Subject: FW: Vickery - Rail spur and regional groundwater flow

In regard to the potential compaction of clays due to the construction of the Vickery Extension Project rail spur (should the Project be approved), the following explains why impacts to regional groundwater flow and storage would not occur:

Figure 19

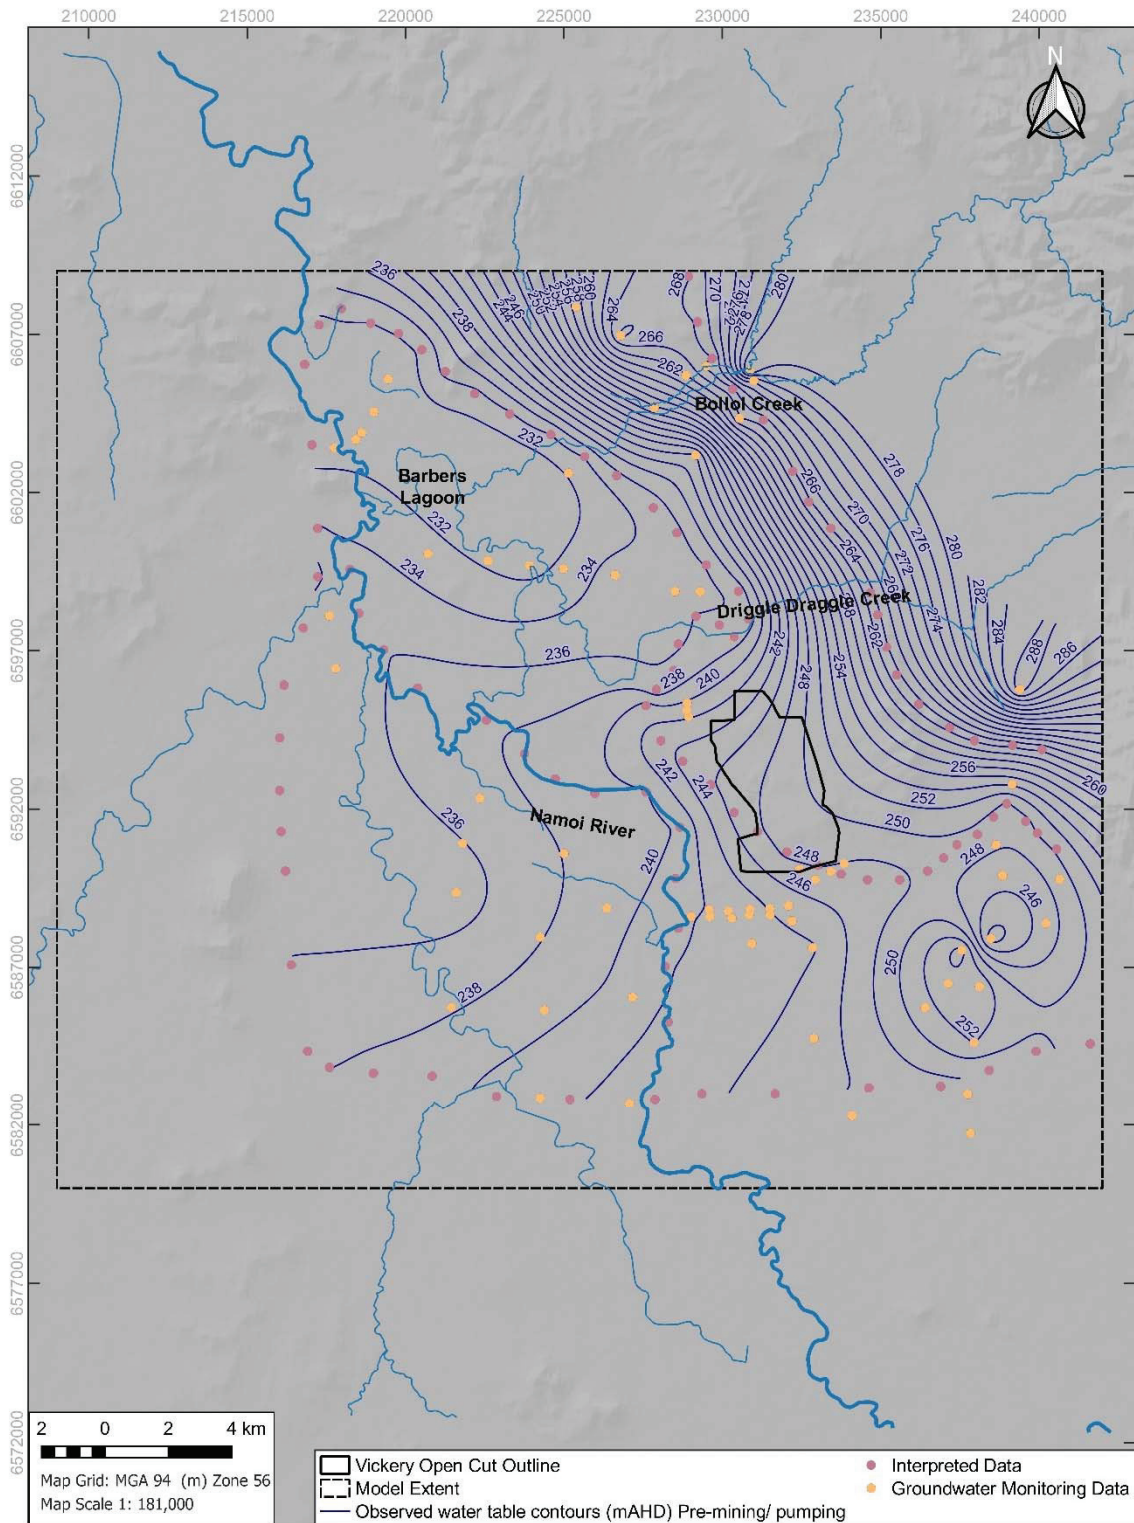
- . On the eastern side of the Namoi River:
 - Groundwater flow in the alluvium is controlled by topography and the Maules Creek Formation.
 - The direction of groundwater flow is approximately east-north-east to west in the vicinity of the rail spur (see attached Figure 19 from the GW Assessment).

- This is approximately the direction of the short section of the rail spur located on

Whitehaven land that may be embankment (see attached Figure 12 from the Submissions Report).

- Therefore any compaction of the clays underlying the rail spur would not form a barrier that constricts groundwater flow.
- Other sections of the rail spur on the eastern side of the Namoi River would be elevated (i.e. to cross South Creek and the Namoi River itself).
- As above, the sands/gravels of the underlying Gunnedah Formation (up to approximately 90 m deep in this area) are less susceptible to compaction than the overlying clays.

Figure 10 Modelled Alluvium Thickness (m)

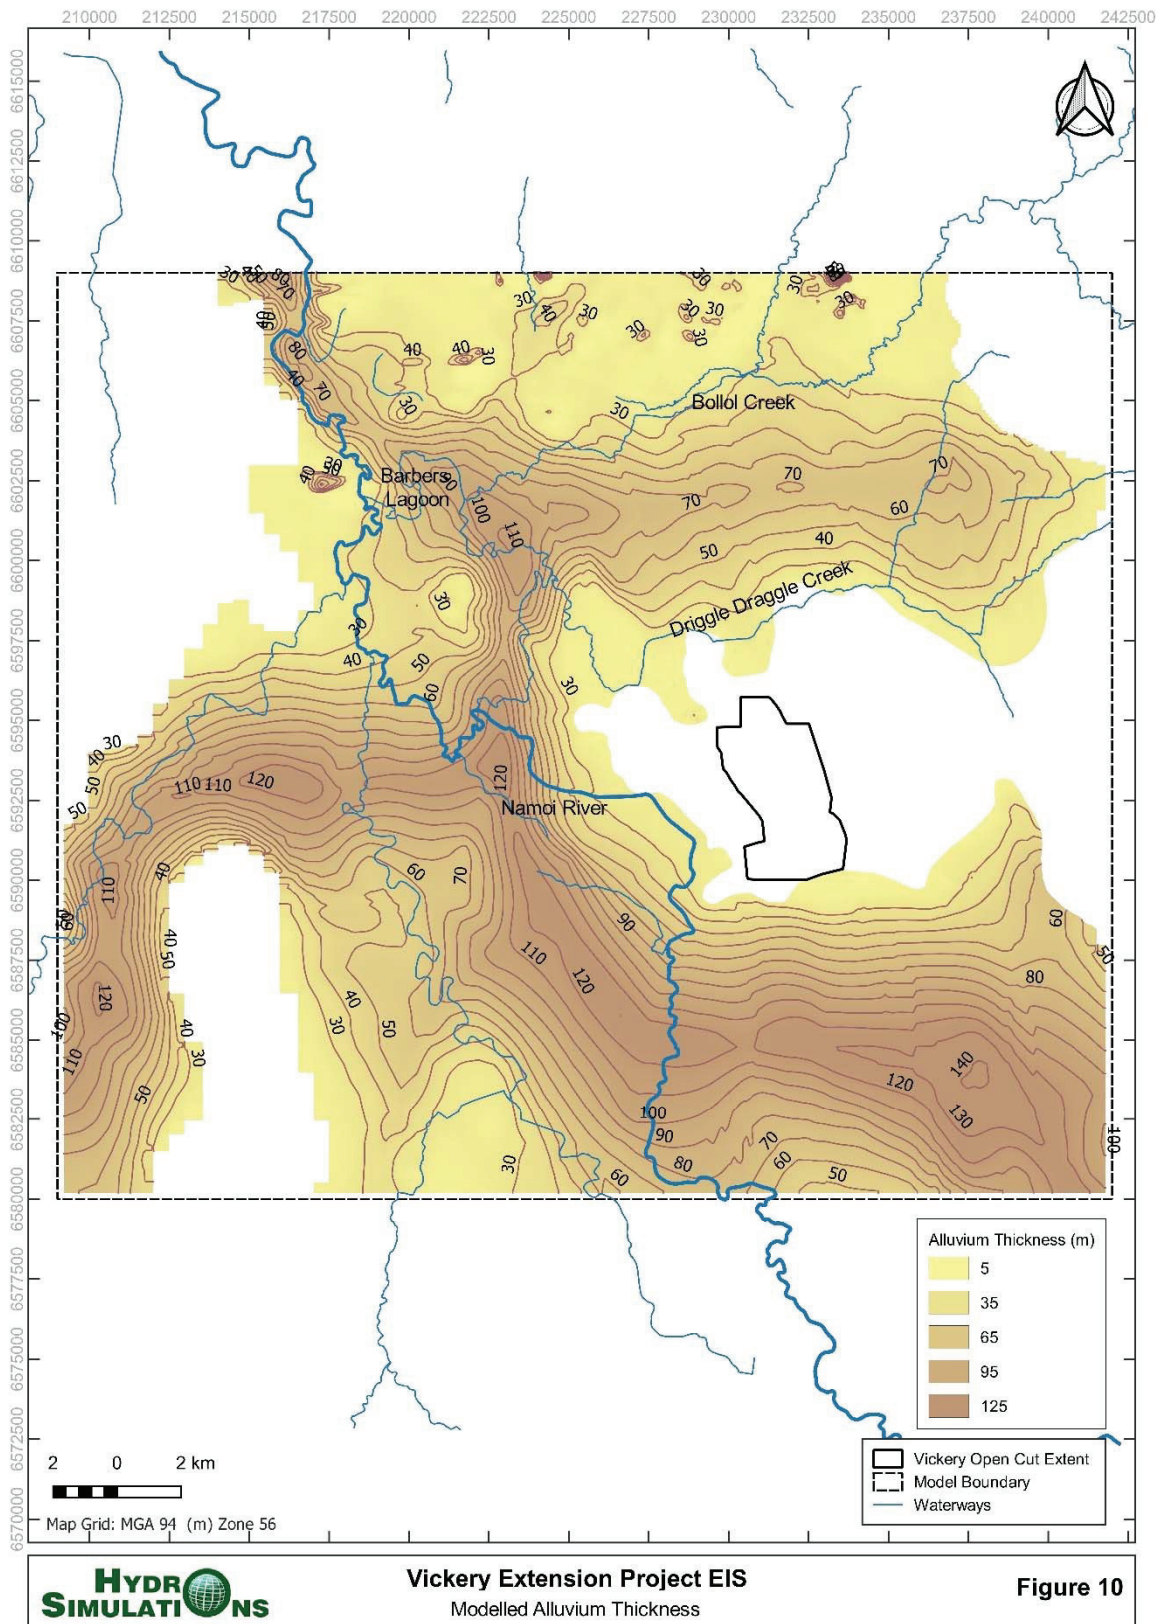
- . The Gunnedah Formation is up to 120 m thick in the vicinity of the Project rail spur (refer to the attached Figure 10 from the GW Assessment).
 - . On the western side of the Namoi River:

Figure 4-5

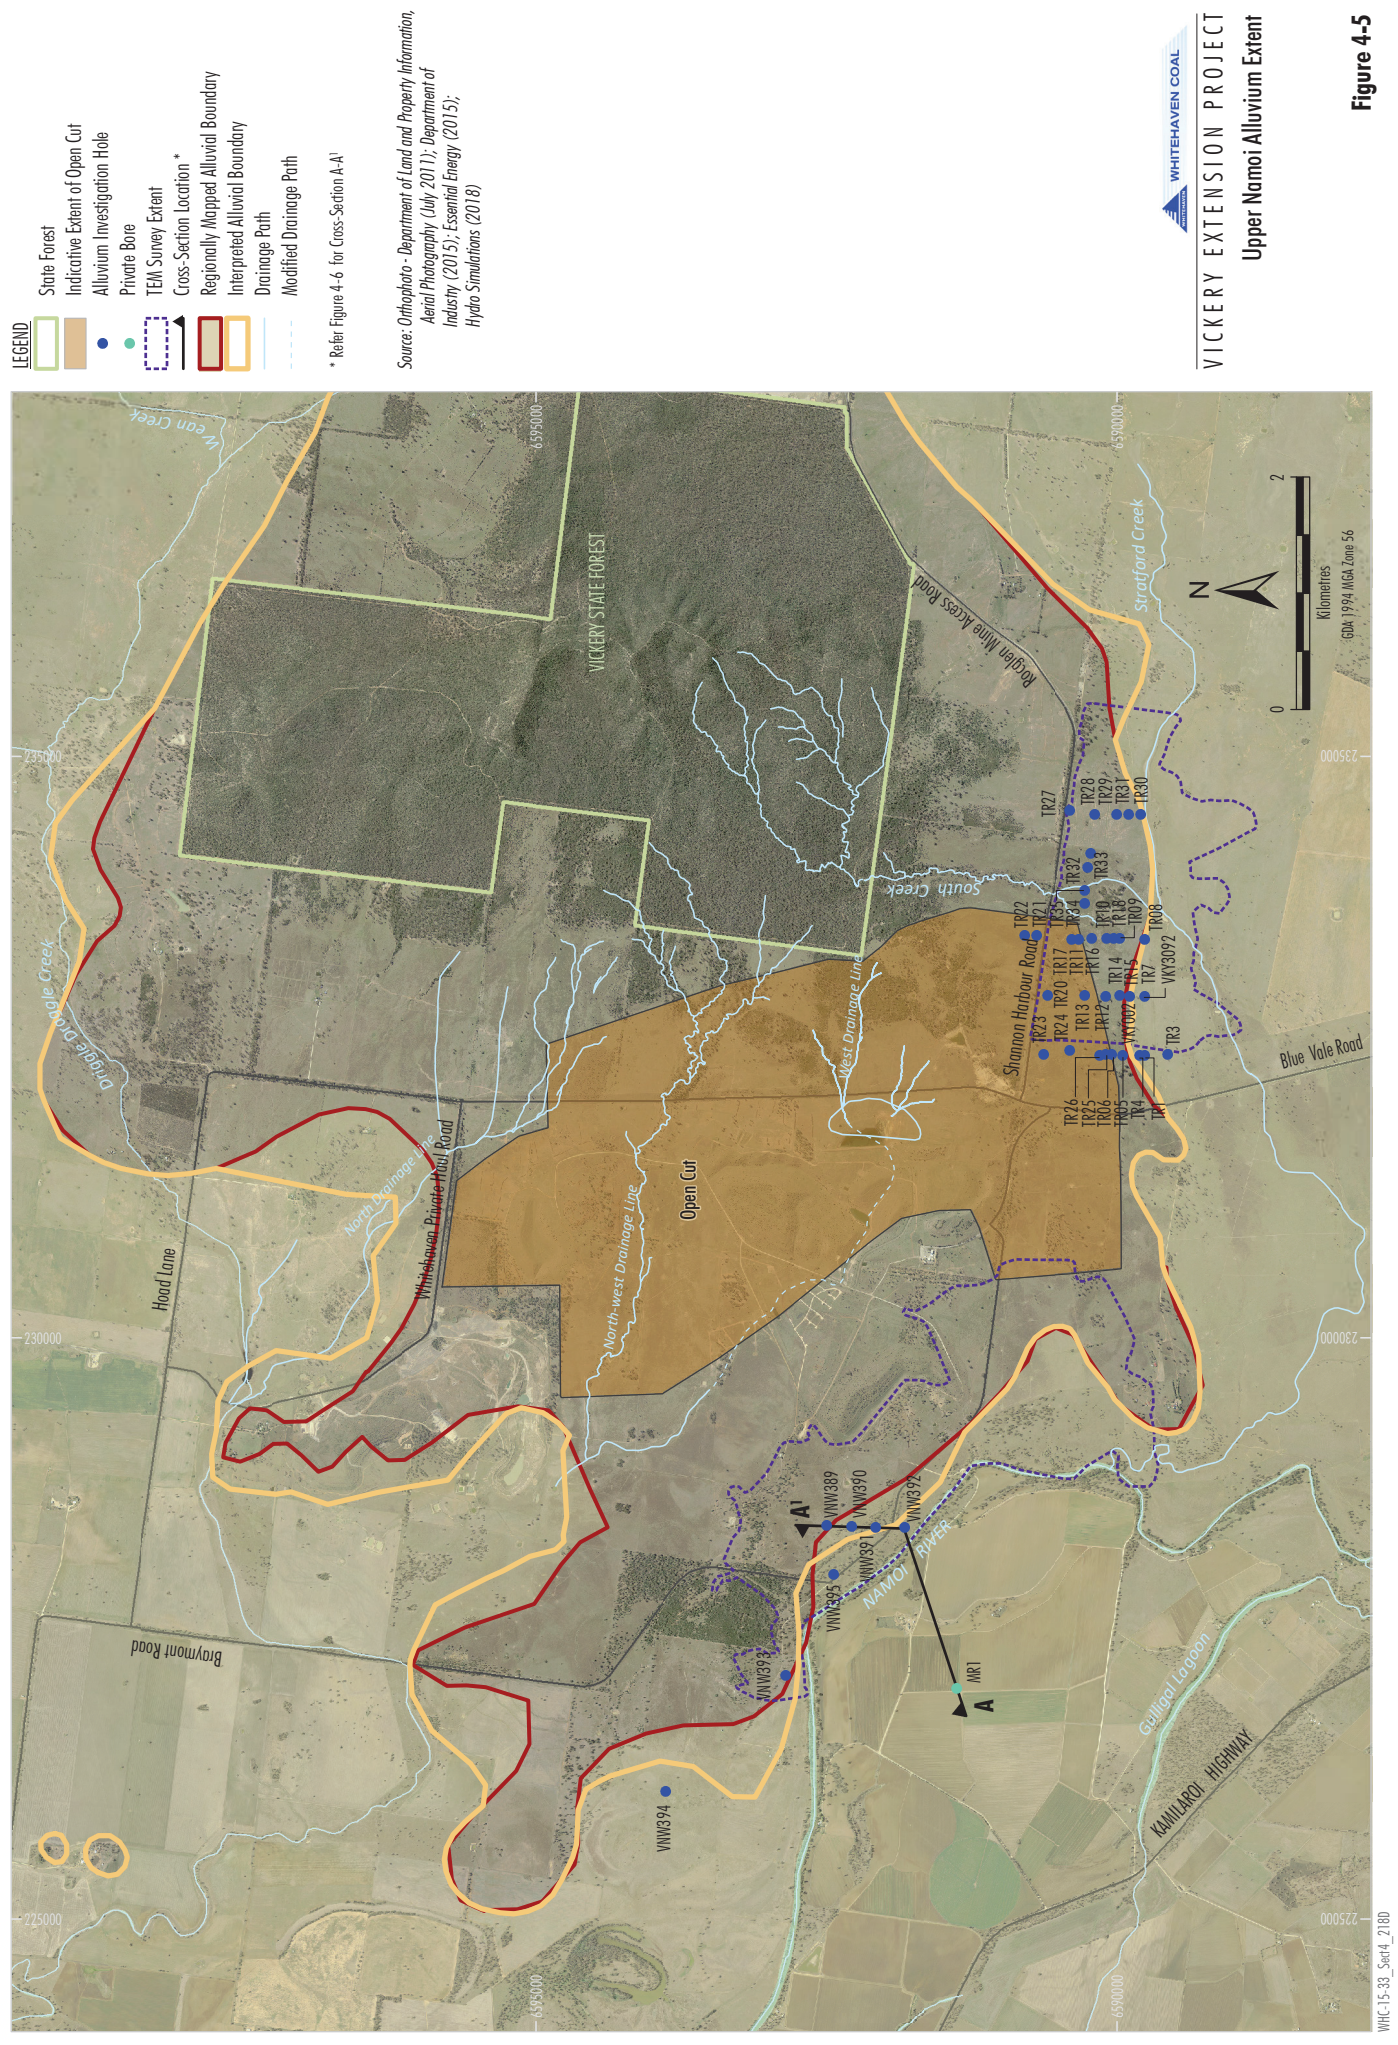
- . The attached Figure 4-5 from the EIS shows drill chips from both the Gunnedah and Narrabri Formations, showing the difference in composition (i.e. sand/gravel vs clay, respectively).
